<b>SUNDRY NOTICES AND REPORTS ON WELLS</b> (DO NOT USE THIS FORM FOR PROPOSALS TO DRILL OR TO DEEPEN OR PLUG BACK TO A DIFFERENT RESERVOIR. USE "APPLICATION FOR PERMIT" (FORM C-101) FOR SUCH PROPOSALS.)		WELL API NO. 30-005-28029

## **Cano Petro**

### **Plug And Abandonment Procedure**

#### **Cato San Andres #561**

## Proposed Wellbore Diagram

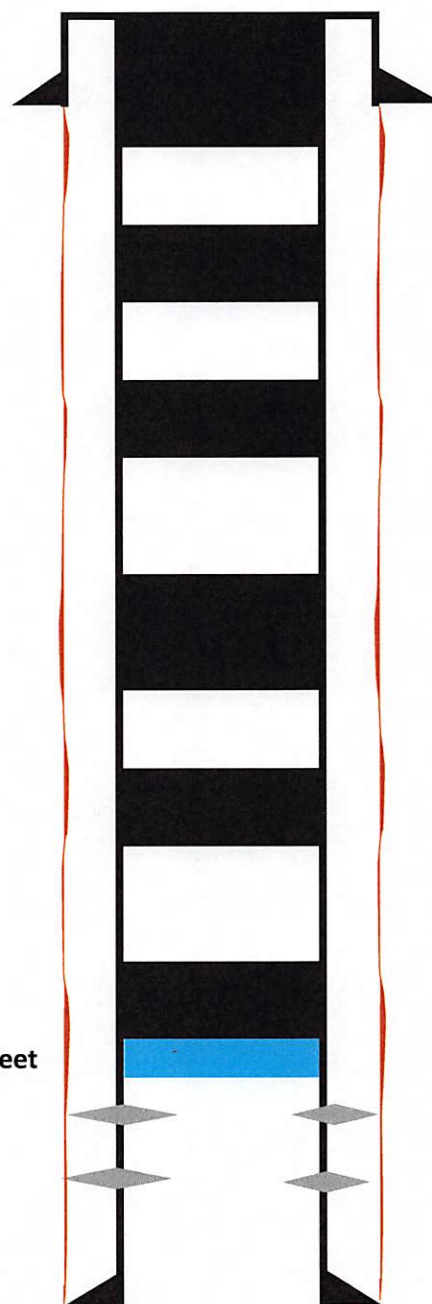
Perf & Sqz all csg shoes.  
 Perf & Sqz all plugs w/ no cmt behind pipe.  
 Adhere to NMOCD COAs attached.
